**{In Archive} West Lake Landfill: Region 7 DRAFT feedback on Batch 3 SFS  
RTCs**

As you requested in this afternoon's update call, here is my DRAFT feedback on all the Batch 3  
RTCs:

**EPA General Comment No. 2, EPA Additional Comments No. 1, 2, 14, 15, 16, 30, 37, 42, 44, and 47 and MDNR Section-Specific Comments 19 and 116 – RIM Characterization**

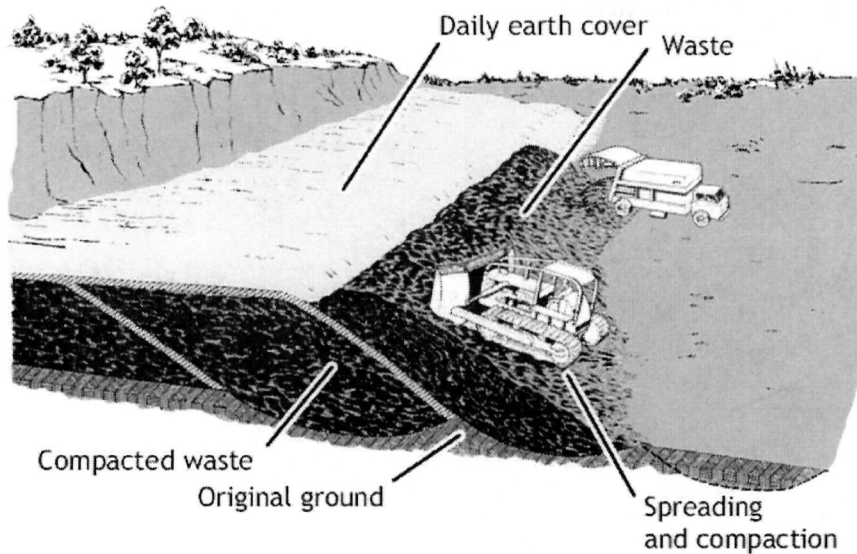
The conceptual models of the nature and distribution of the RIM developed by the NRC investigations and the RI differ significantly. The 1988 NRC report states "In general, the contamination appears to be a continuous single layer ranging from 2 to 15 feet thick and covering 16 acres." It should be noted that this characterization appears to be in conflict with the graphical characterization portrayed on Figure 14 of the NRC report. Review of this figure, including adjusting to account for the fact that the figure does not represent a true cross-section (i.e., the figure does not present the borings in order or directional sequence and does not post results for adjacent borings next to each other), indicates that there are large variations in both the activity levels and the elevations at which radionuclides were identified by the NRC in Areas 1 and 2.
